Access Compliance Report

Public Rights-of-Way

(Curb Ramps)

Intersection ID: 16520	Main Street: ORCHARD_CR	Cross Street: S_TRYON_ST	Location: W
ADA ID: D7E4B06EDDB5	Ramp Type: PerpDiag	Initial Pass/Fail: Fail	Overall Compliance: No
		Severity Score: 72.5

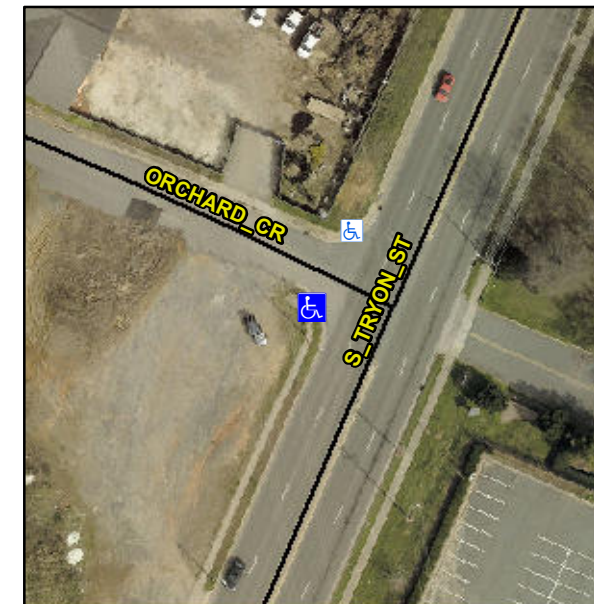
Remove & Replace Curb Ramp With Two New Directional Ramps or Equivalent.

R304.5.1, R304.2.2, R304.5.3
